SERVICE BULLETIN

PURPOSE : INFORMATION
 ISSUE NO. : MSB-12E11_13_16_23-001
 DATE : 2012-01-27

SUBJECT : INFORMATION ON 2012MY 4B1-N/A,4J1,4N1
 <MODEL> (EU) 12

GROUP : ENGINE / FUEL / ENGINE ELECTRICAL / CVT
 Outlander(CW0W),Lancer(CY0A) Lancer Sportback(CX0A),ASX(GA0W))

<When tension is measured>

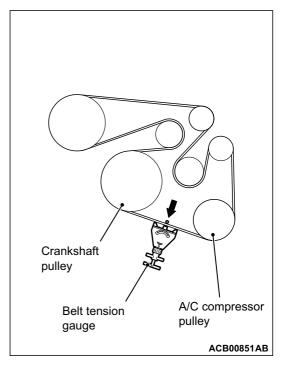
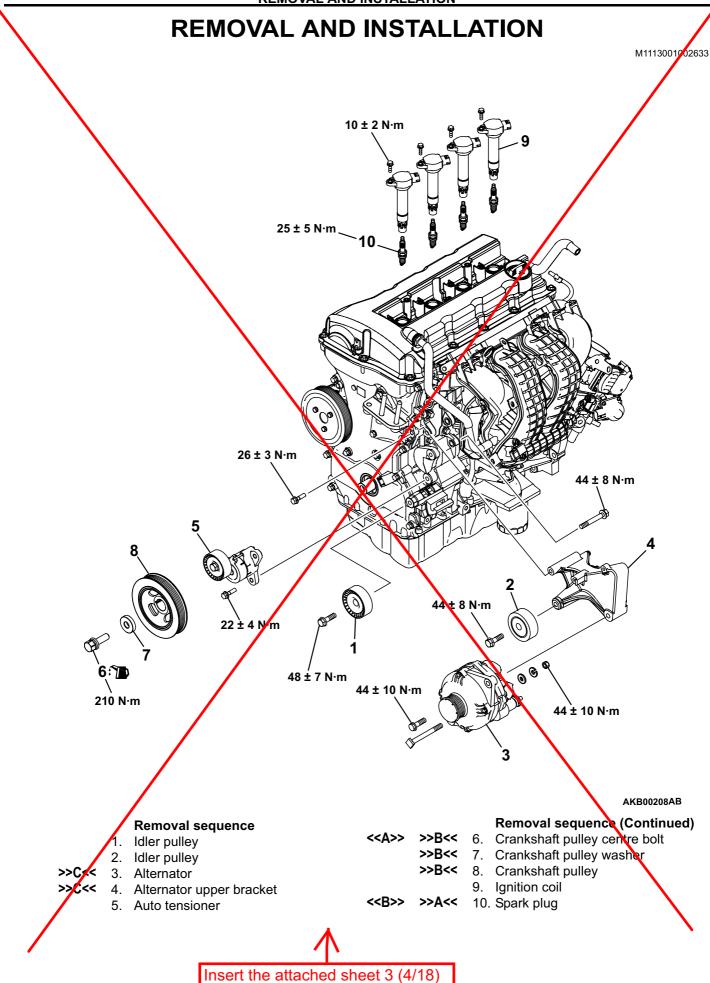
1) 4B1-N/A, 4J1 Engine : Abolishment of One way Clutch (Drive Belt Auto-Tensioner)

1. Check the tension of the drive belt (Refer to).

2. Use a belt tension gauge in the middle of the drive belt between the pulleys shown in the figure (at the place indicated by the arrow) to check that the drive belt tension is within the standard value.

115 156 Hz

Standard value (Reference): 265 440 N

234 -421 N

REMOVAL AND INSTALLATION

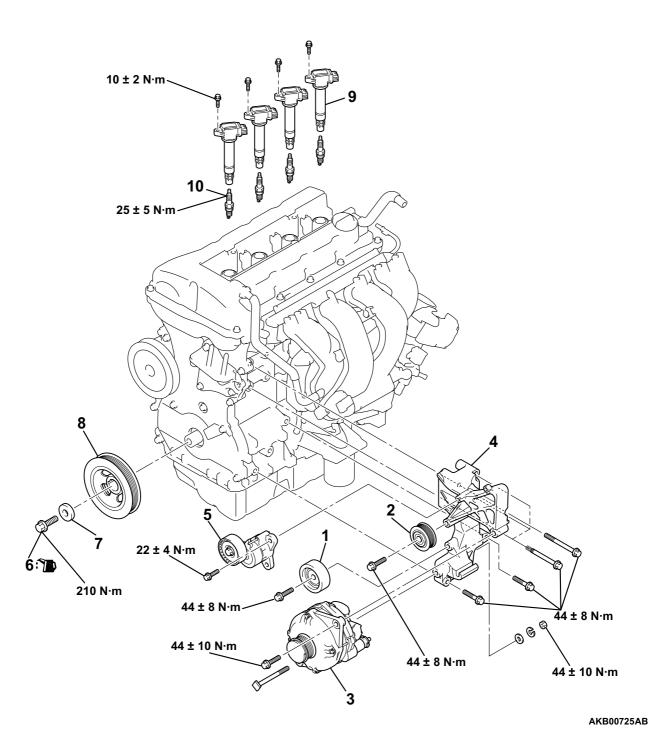
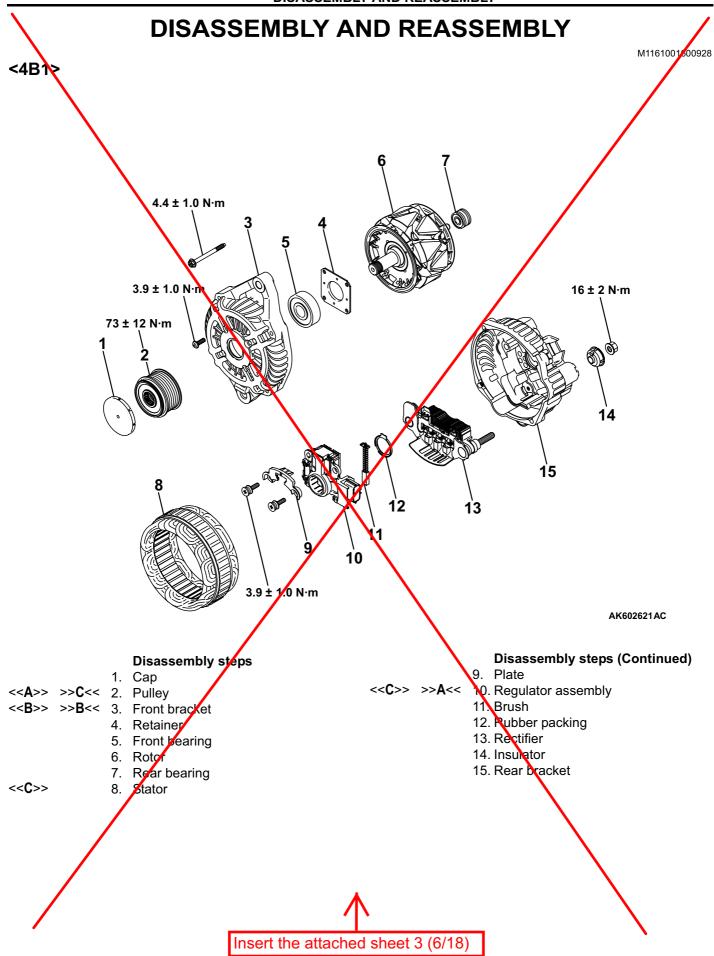
Rationalization of Alternator Bracket

Removal sequence

- 1. Idler pulley
- 2. Idler pulley
- 3. Alternator
- 4. Accessory bracket
- 5. Auto tensioner

<4B1>

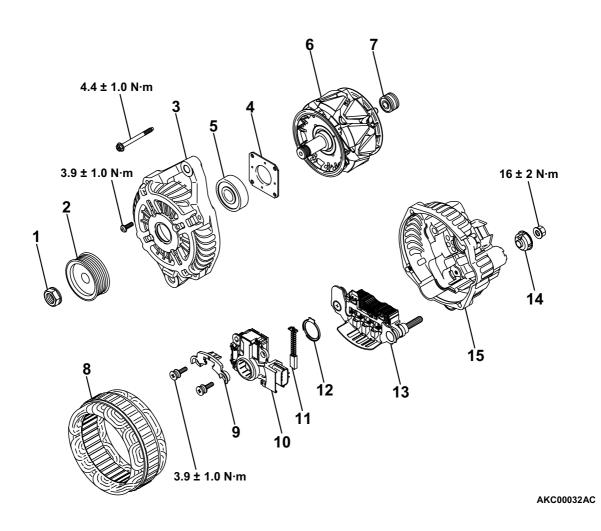
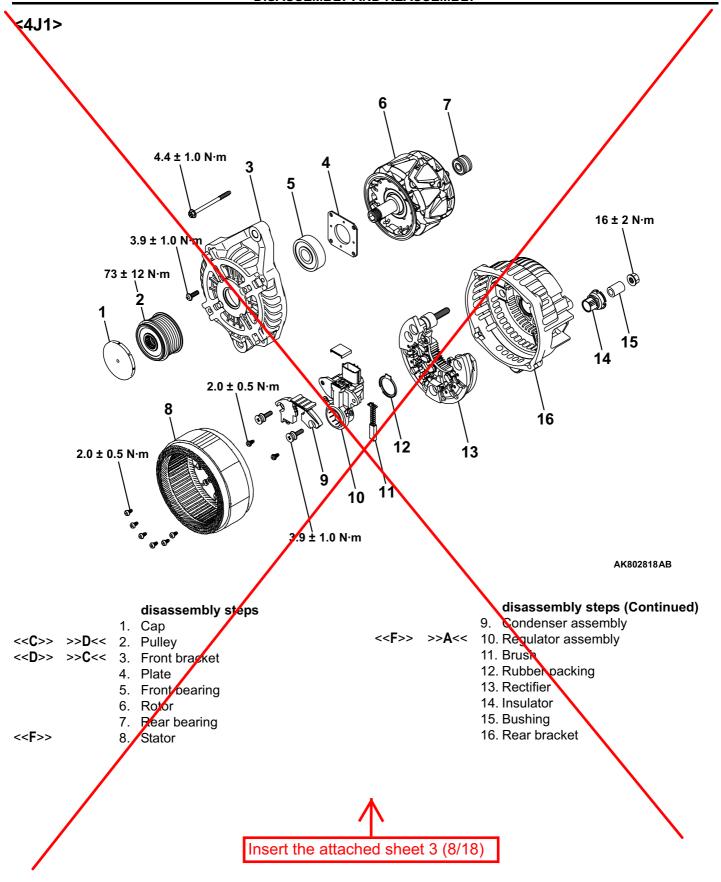
Disassembly steps

DISASSEMBLY AND REASSEMBLY

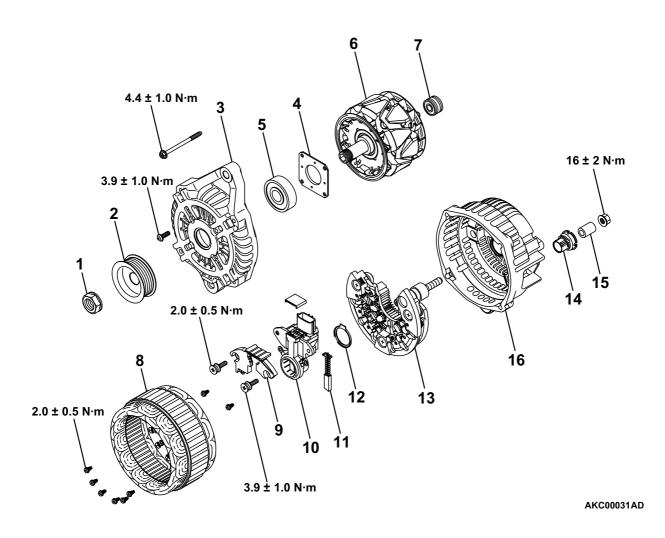
disassembly steps

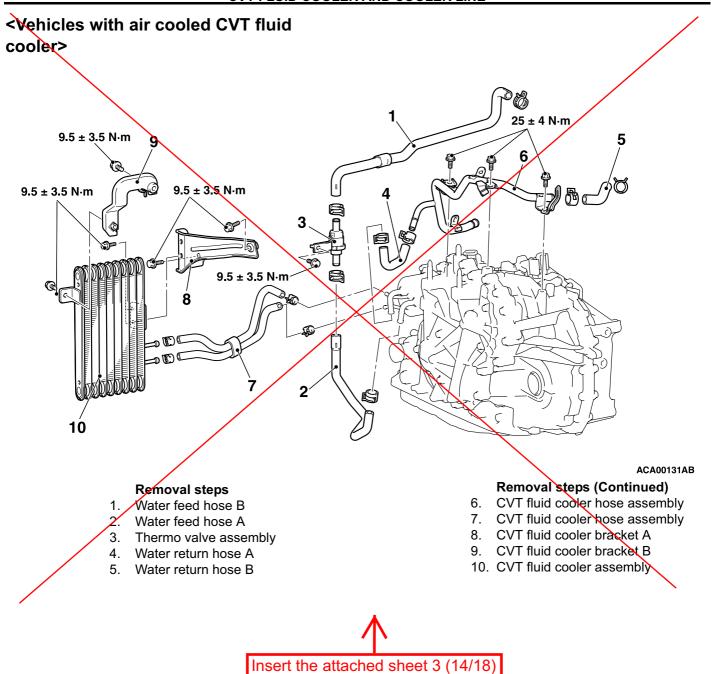
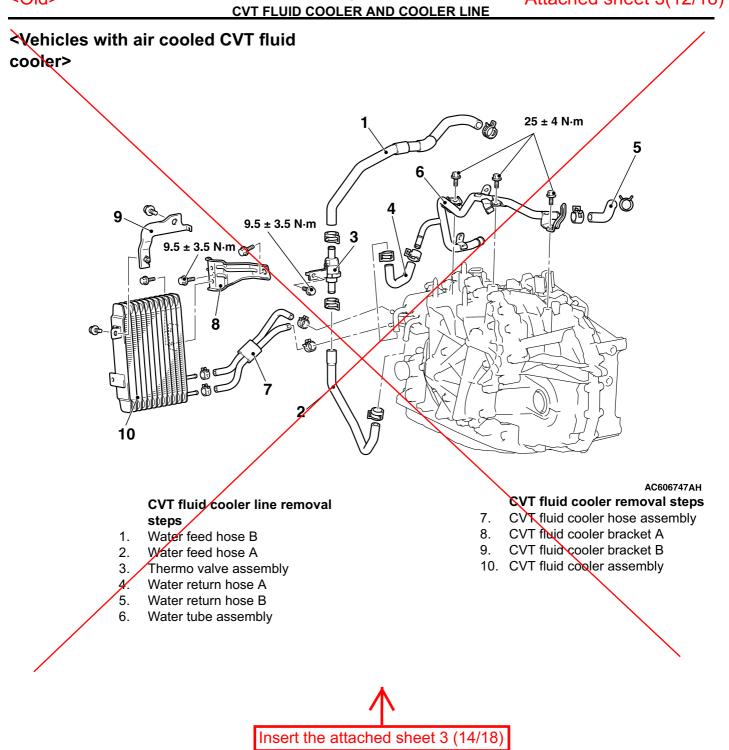
3) CVT : Abolishment of Thermo Valve

CVT FLUID COOLER AND COOLER LINE REMOVAL AND INSTALLATION M1231210800133 Pre-removal and post-installation operation Engine Room Under Cover Front A, B, Engine Room Side Cover (Refer to GROUP 51 - Under Cover .) CVT Fluid Draining and Refilling (Refer to .) Engine Coolant Draining and Refilling (Refer to GROUP 14 - On-vehicle Service, Engine Coolant Replacement .) Air Cleaner Intake Quct (Refer to GROUP 15 - Air Cleaner Battery and Battery Trax Removal (Refer to GROUP 54A - Battery .) <Vehicles without air cooled CVT fluid</p> cooler> 25 ± 4/N·m 9.5 ± 3.5 N·m AC904248AB Removal steps (Continued) Removal steps Water return hose A Water feed hose B Water return hose B 5. Water feed hose A Water tube assembly Thermo valve assembly Insert the attached sheet 3 (13/18)

CVT FLUID COOLER AND COOLER LINE REMOVAL AND INSTALLATION M1231212500309 Pre-removal and post-installation operation Engine room under cover front and engine room side cover (Refer to GROUP 51 - Under Cover .) CVT fluid draining and refilling (Refer to .) • Engine coolant draining and refilling (Refer to GROUP 14 - On-vehicle Service - Engine Coolant Replacement .) Air cleaner intake duct (Refer to GROUP 15 - Air Cleaner Battery and Battery Tray Removal (Refer to GROUP 54A, Battery). <Vehicles without air cooled CVT fluid</p> cooler> 25 ± 4 N·m 9.5 ± 3.5 N·m AC705664AC Removal steps (Continued) Removal steps Water return hose A Water feed hose B Water return hose B Water feed hose A Water tube assembly Thermo valve assembly Insert the attached sheet 3 (13/18)

CVT FLUID COOLER AND COOLER LINE REMOVAL AND INSTALLATION M1231212500280 Pre-removal and post-installation operation • Engine room under cover front, engine room side cover (Refer to GROUP 51 - Under Cover .) Front bumper extension A, B, transmission fluid cooler duct (Refer to GROUP 51- Front bumper assembly .) Engine coolant draining and refilling (Refer to GROUP 14 - On-vehicle Service - Engine Coolant Replacement .) Air cleaner intake duct (Refer to GROUP 15 - Air Cleaner <4B11>, <4B12>.) Engine coolant draining and refilling (Refer to GROUP 14 - On-vehicle Service - Engine Coolant Replacement .) Battery and Battery Tray Removal (Refer to GROUP 54A - Battery .) 25 ± 4 N·m 3.5 N⋅m 🦟 18 ± 7 N⋅m AC606747AF CVT fluid cooler removal steps **CVT** fluid cooler line removal CVT fluid cooler hose assembly steps CVT fluid cooler bracket A Water feed hose B CVT fluid cooler bracket B Water feed hose A 10. CVT fluid cooler assembly 3. Thermo valve assembly 4. Water return hose A 5. Water return hose B
